**BOARD OF ZONING ADJUSTMENT
STAFF REPORT****Date: July 10, 2017****CASE NUMBER**

6119/ 6063

5054 OSR, LLC

5070 and 5054 Old Shell Road
(Northeast corner of Old Shell Road and Border Drive North and the West side of Border Drive North, extending to the East side of Parkway East, 220'± North of Old Shell Road.)

SITE PLAN

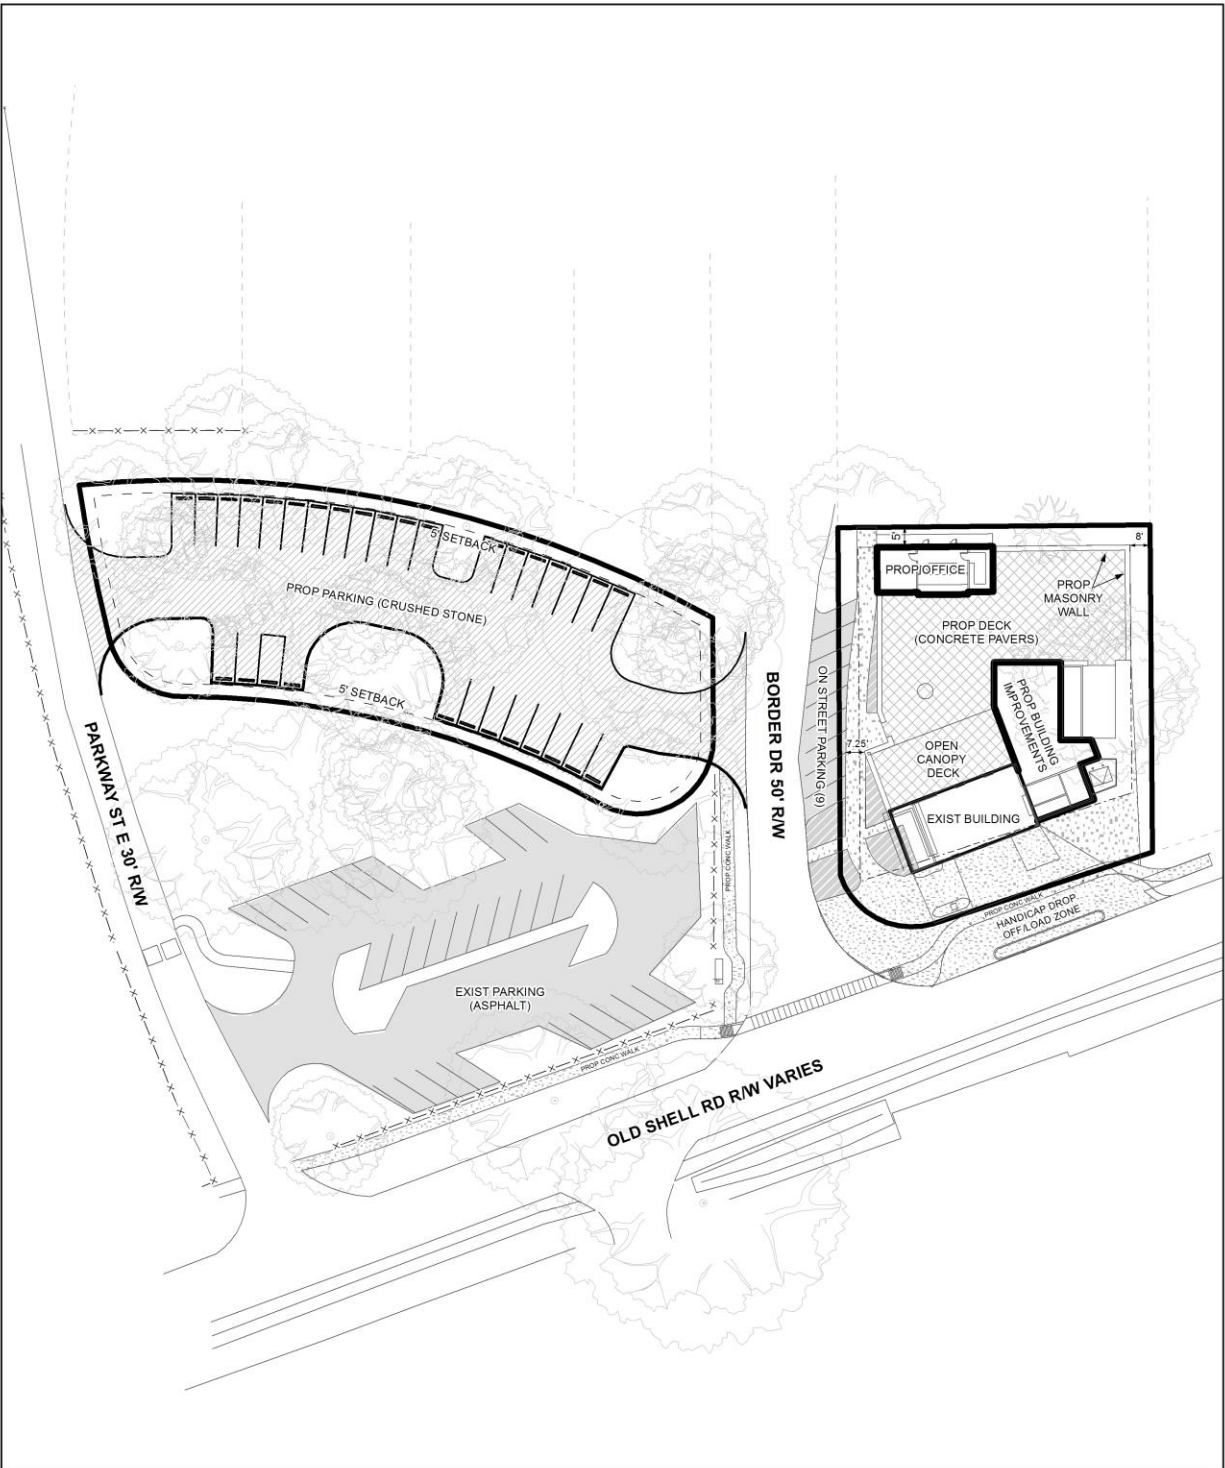
footage information should also be included in the parking calculations as well. A revised site plan providing the total square footage calculations for both indoor and outdoor dining is required so staff can determine if adequate parking will be provided.

Rester Brothers property. An enhanced landscape buffer will be added on the north side of the proposed parking lot to separate the lot from those neighbors to the north". It should also be pointed out that based on the site plan; the rear yard setback does not appear to meet setback compliance either. When evidence is not provided to support the alleged hardship associated with the property staff can only determine that it is merely the applicant's personal desire not to comply, and not that compliance is unobtainable.

A dumpster is depicted on the site plan (although not clearly identified) however staff is concerned about the location and the accessibility of the dumpster. A statement explaining how the dumpster will be accessed should be included in a revised narrative.

Lastly, almost the entire portion of the site between the building and Old Shell Road is paved with concrete with a continuous curb cut. Per Traffic Engineering, this continuous curb cut should be eliminated, with the site being limited to one curb cut to Border Drive East. The site plan indicates a new sidewalk and crosswalk will be installed along Border Drive East and along Old Shell Road.

- 1) Revised narrative explaining in detail the hardship for the use, side street side yard setback, surfacing, reduced landscape and multiple structure variance request;
- 2) Revised narrative explaining accessibility to the dumpster;
- 3) Revised tree and landscape plan separately depicting the tree planting and landscape calculations for the property with the proposed restaurant and the proposed parking lot;

- 4) Revise the tree and landscape plan to space out the 3 live oak trees in front of the proposed restaurant;
- 5) Revise tree and landscape plan to specifically depict what trees if any will be used for tree credits;
- 6) Revised site plan providing the total square footage calculations for both indoor and outdoor dining is required so staff can determine if adequate parking will be provided; and
- 7) Meeting with the neighborhood to discuss possible traffic concerns.

LANDSCAPE SITE PLAN

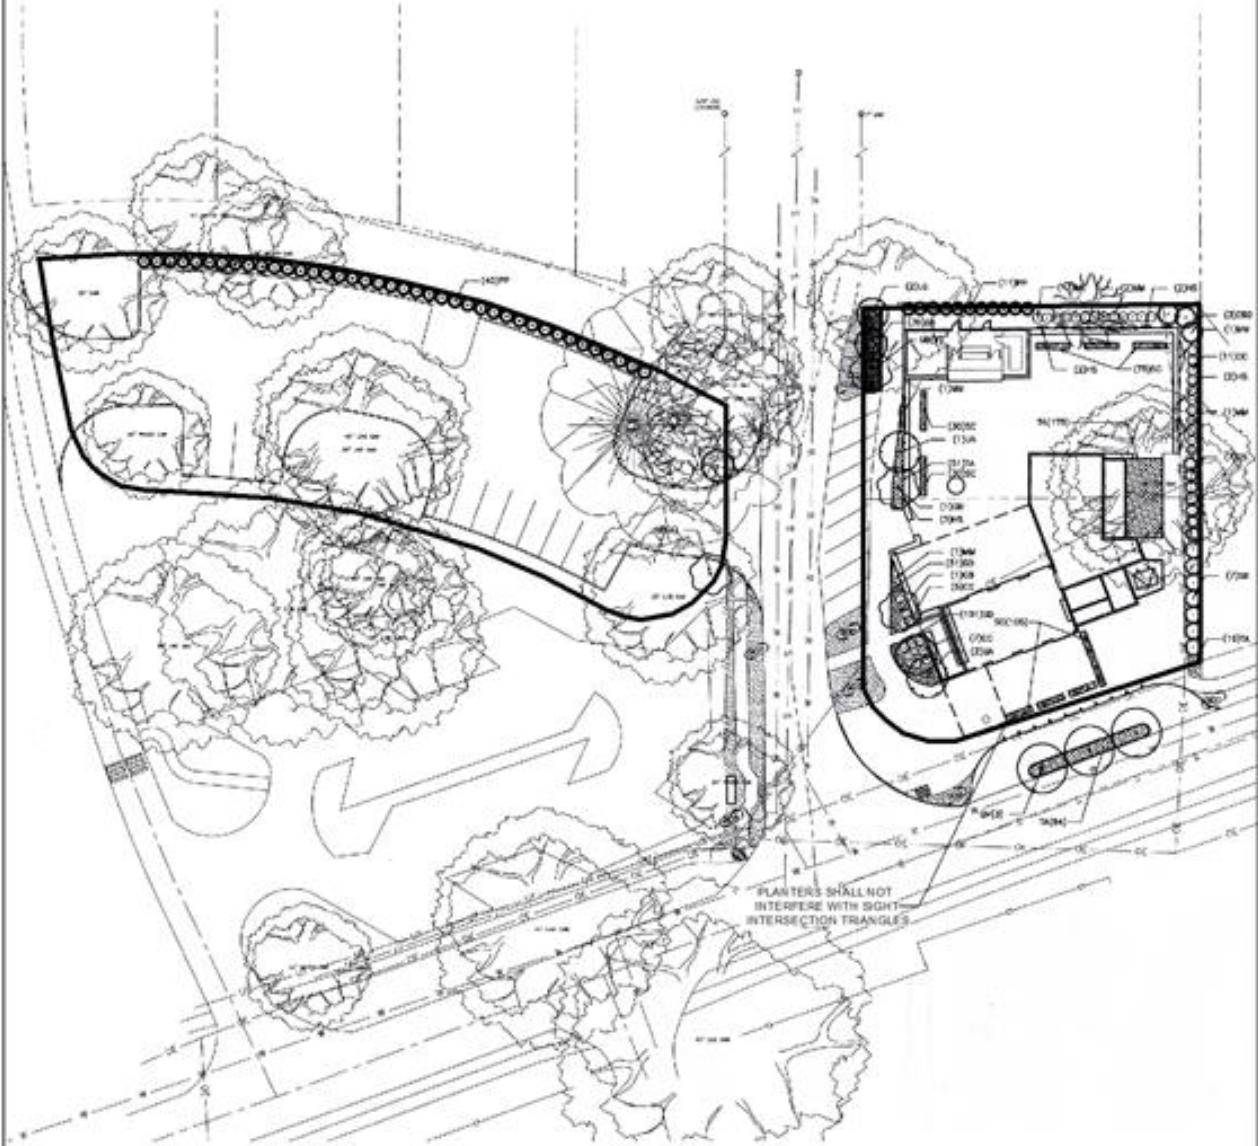
The applicant also requested a reduced landscape area variance because the site as proposed would not be able to provide compliance with front landscape area. Based on the landscape calculations provided by the applicant, the site would in fact be in compliance if the calculations were correct; however staff has determined that there are some discrepancies with the landscape plan. For clarification purposes the tree and landscape plan should be revised to separate and clearly depict the tree and landscape calculations for the restaurant property as well as the calculations for the parking lot. The frontage tree and perimeter tree calculations are incorrect and should be revised. Based on staff's calculations the proposed restaurant property should have 8 frontage trees and 8 perimeter trees. The proposed parking lot property should have 3 frontage trees, 15 perimeter trees, and 3 parking trees (parking tree calculations are subject to change based on outdoor seating square footage calculations). Staff is aware that there are many existing trees on site and applicant may have intentions on using some of the existing trees for credits; however those trees should be specifically identified on the tree and landscape plan. There also appear to be several large heritage trees depicted on a separate site plan that are located on private property that are not shown on the tree and landscape plan. Please note private property tree removal applications will be required for the removal of each tree. Staff also has some concern regarding the placement and close proximity of the 3 live oak trees that are proposed in front of the restaurant property and would recommend spacing the trees to allow more room for each tree to grow.
